PREVOST

Warranty Bulletin

96-03

Subject: **ELECTRIC SUPPLY MODIFICATION ON LEVEL LOW SYSTEM**

FIGURE 1

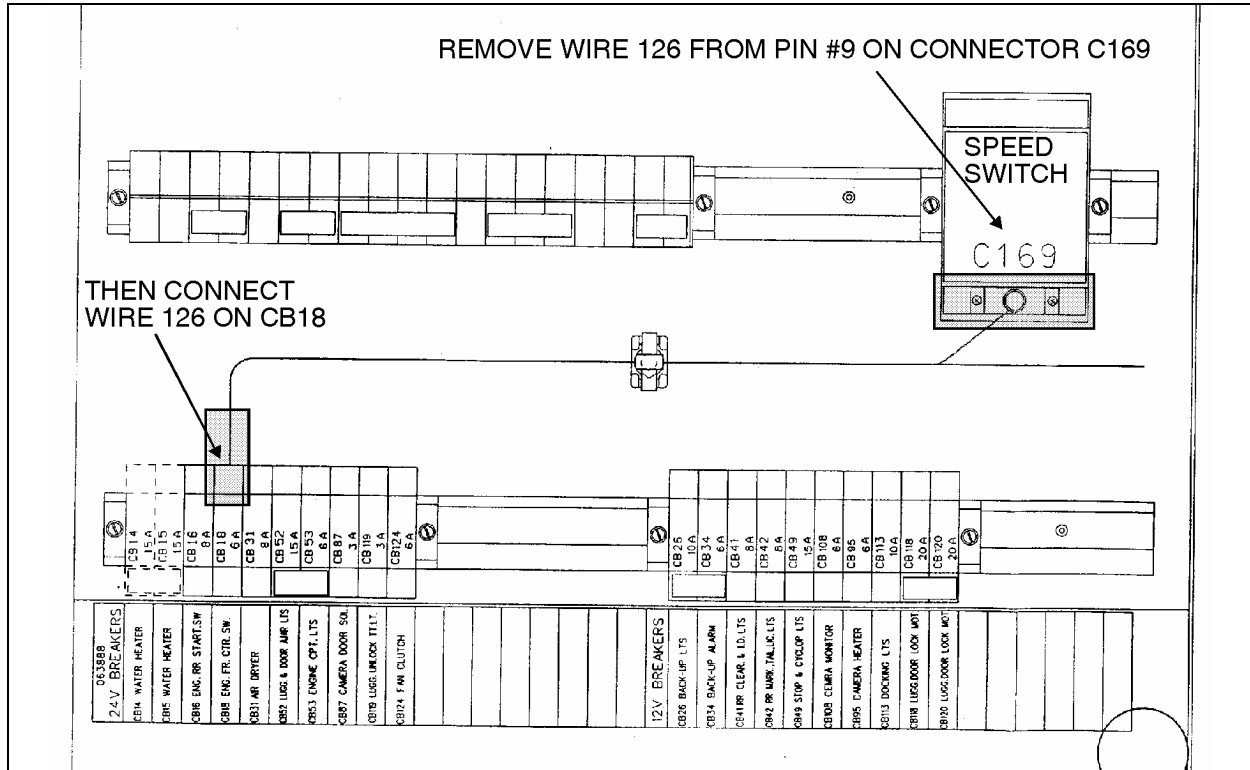
1. In rear electrical compartment (L.H. side of vehicle), locate speed switch (Fig. 1).

2. Disconnect wire 126 from pin #9 of C169 connector on speed switch.
3. Strip $\frac{1}{2}$ " on extremity of wire 126, then insert shrink tubing on wire. On 18 gauge red wire, strip $\frac{1}{2}$ " on extremity with no terminal.
4. Join the two stripped extremity of the wires, and solder. Slide shrink tubing over soldered area, then shrink tube using a match, a lighter or a heat gun.
5. Connect other extremity of wire to CB18 circuit breaker (Fig. 1), on the same side as wire 85B.
